COMMITTEE OF THE WHOLE SEPTEMBER 15, 2003

**BLOCK 18 BLOCK PLAN
CARRVILLE – URBAN VILLAGE 2
BLOCK PLAN FILE: BL.18.98**

BLOCK 18 PLAN

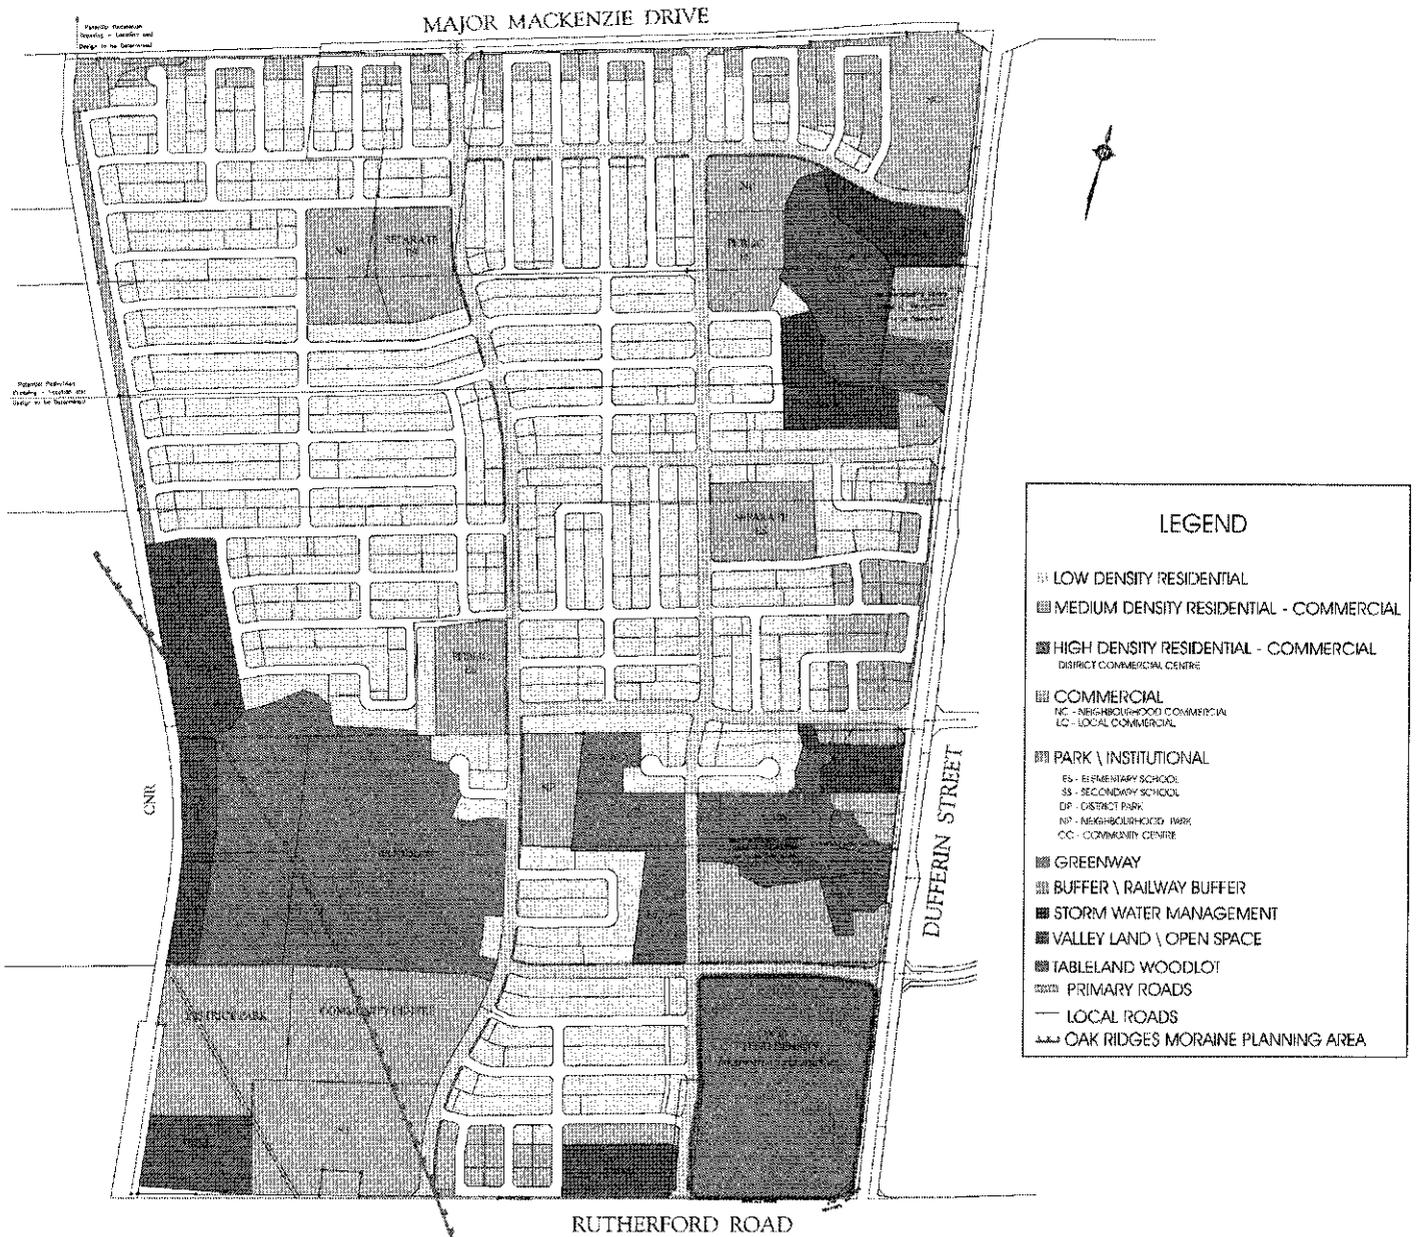
- road links to improve internal connectivity are now sufficient for the movement of traffic to and from the Block.
- the number of residential driveways fronting on to the primary road gateways have been minimized, by providing commercial sites, institutional uses, stormwater management ponds and rear residential lots at these corners.

- the revised Block Plan indicates a potential pedestrian crossing from the northwest part of the Block across Major Mackenzie Drive to the Maple GO Train Station, which will be subject to further investigation to determine the feasibility of the crossing.

- the revised Block Plan indicates the boundary of the Oak Ridges Moraine.
- the references to "Study Area for SWM Ponds" and "Plantation Woodlot" have been deleted from the Block Plan.

BLOCK 18 PLAN

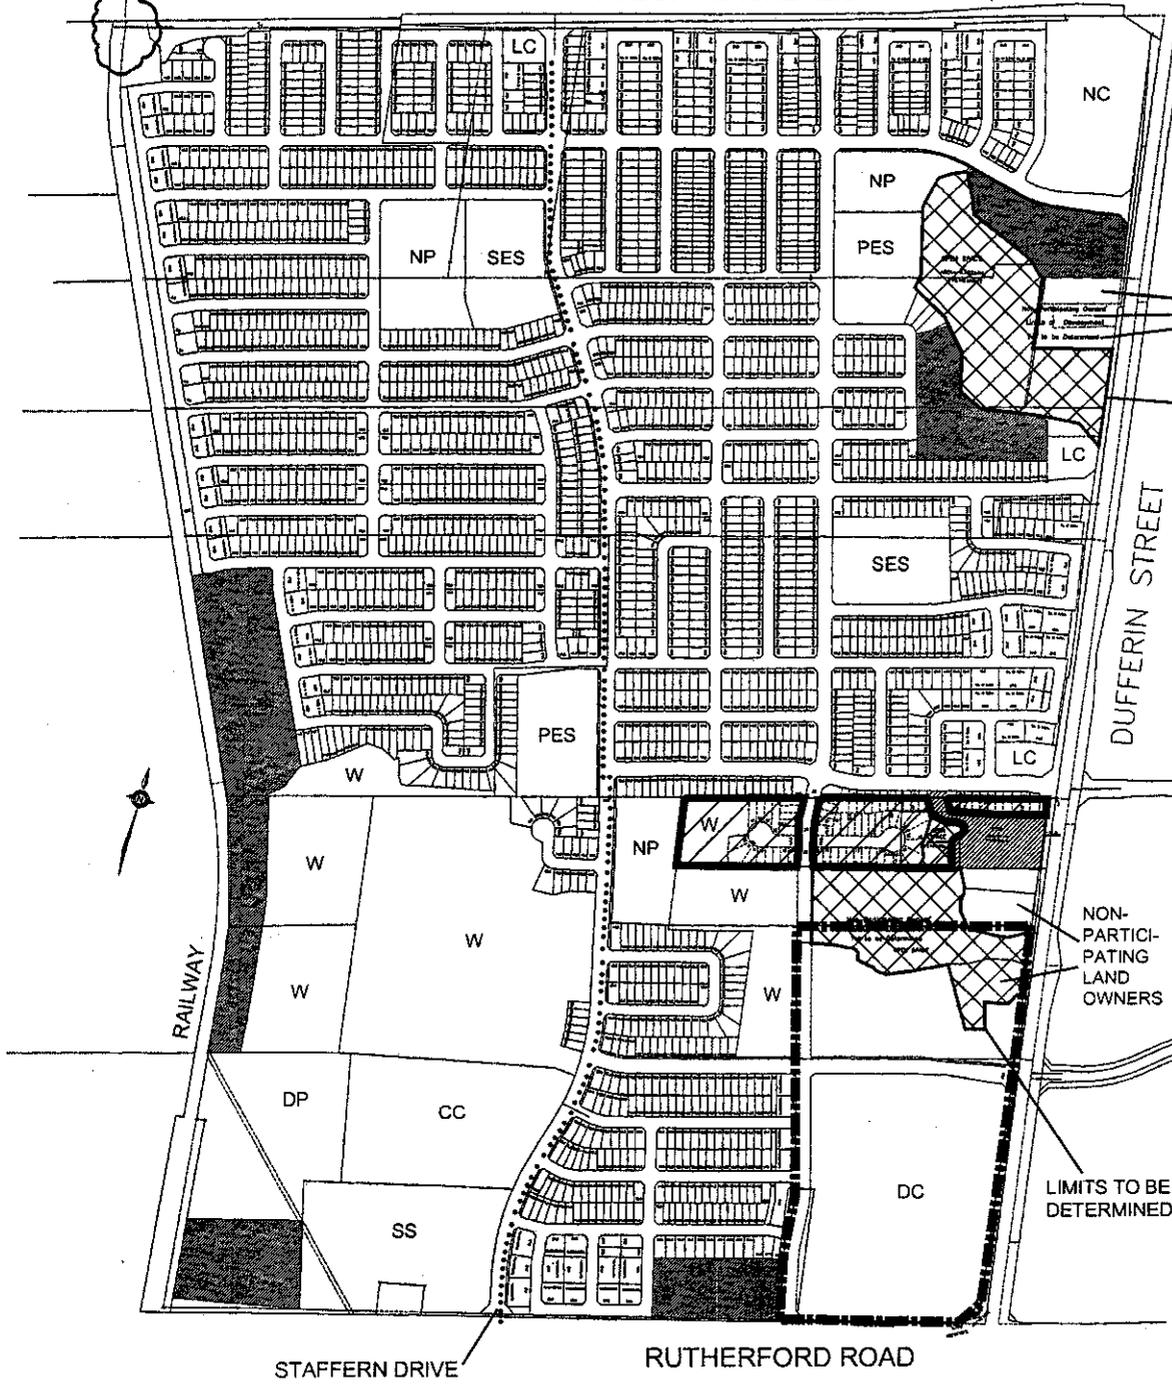
- a) That for lands subject to the Oak Ridges Moraine Conservation Plan, conceptually identified on Attachment 4 as “Land Uses & Stormwater Management Pond Limits to be Determined”, limits of features shall be determined on site with City and TRCA staff and an addendum to the Master Environmental Servicing Plan shall be prepared demonstrating conformity of the Block Plan with the Oak Ridges Moraine Conservation Plan to the satisfaction of the City of Vaughan, Region of York and TRCA.
- b) That the supporting reports for the Block be revised according to the requirements outlined in this report and resubmitted to the City for approval.

- l) That when the City approves the ORM conformity report it will become an addendum to the supporting Block Plan reports. The limits of the environmental features in lands identified on Attachment 4 as "Lands Uses & Stormwater Management Pond Limits to be determined" are to be confirmed by the City and the TRCA prior to the approval of a lot

Sidewalk & Traffic Calming Plan

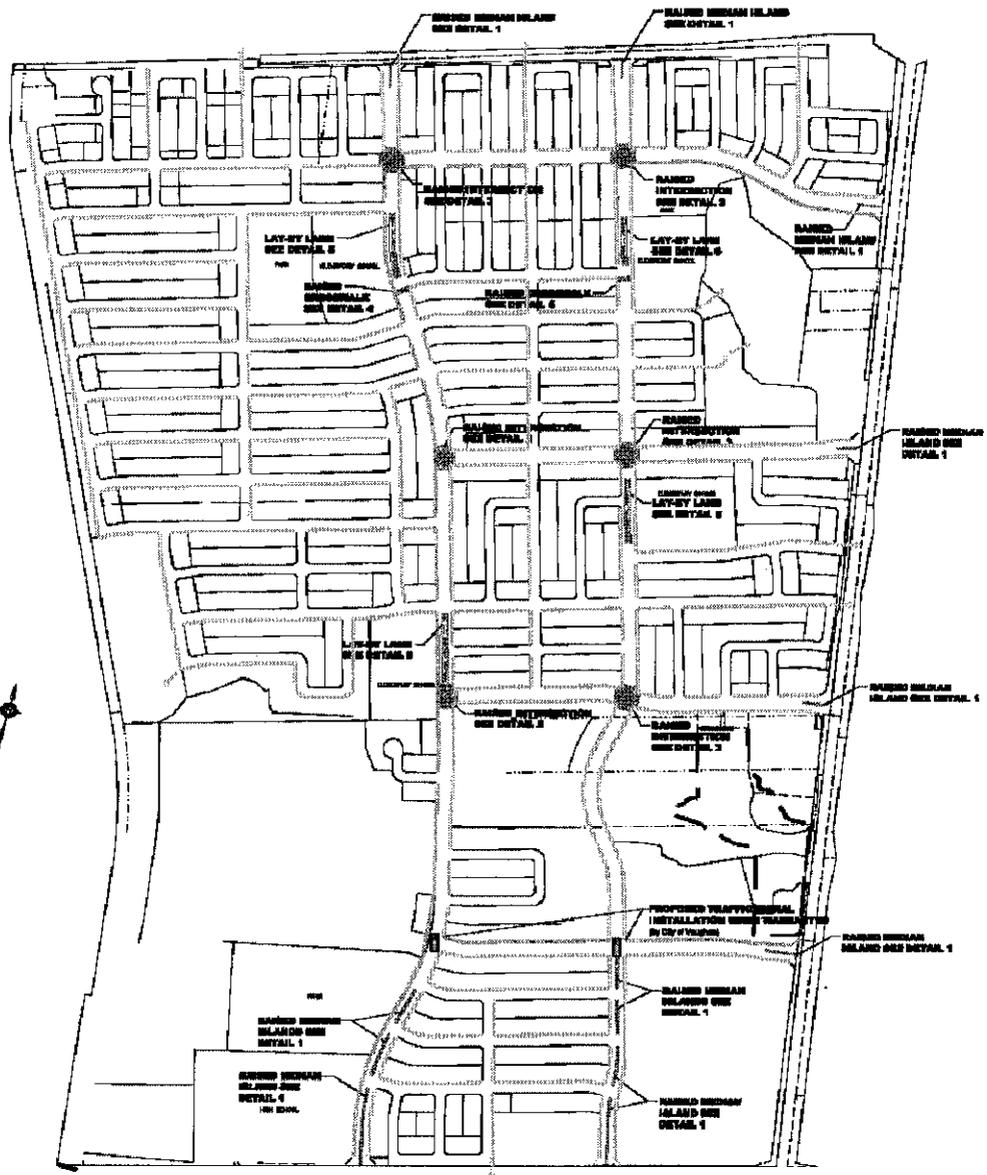
- the Traffic Calming Plan appears to be excessive; the mid-block circles are to be removed and the lay-by-lanes adjacent to the schools are to be located within the r-o-w. and not within the traveled portion of the pavement.

- intersection signal control is required at the south primary road/east primary road and south primary road/west primary road intersections.
- a Sidewalk Plan has been included in the *Traffic Analysis*, however, to ensure that it meets the City's Sidewalk Policy, a full size plan is to be submitted, complete with unit counts tributary to the sidewalks proposed; the Sidewalk Plan is to be co-ordinated with the City's Draft Pedestrian and Bicycle Master Plan Study. The Transportation Management Plan and Sidewalk Plan has been combined to form a single comprehensive Plan that will be incorporated into the final supporting Block Plan reports (Attachment 6).
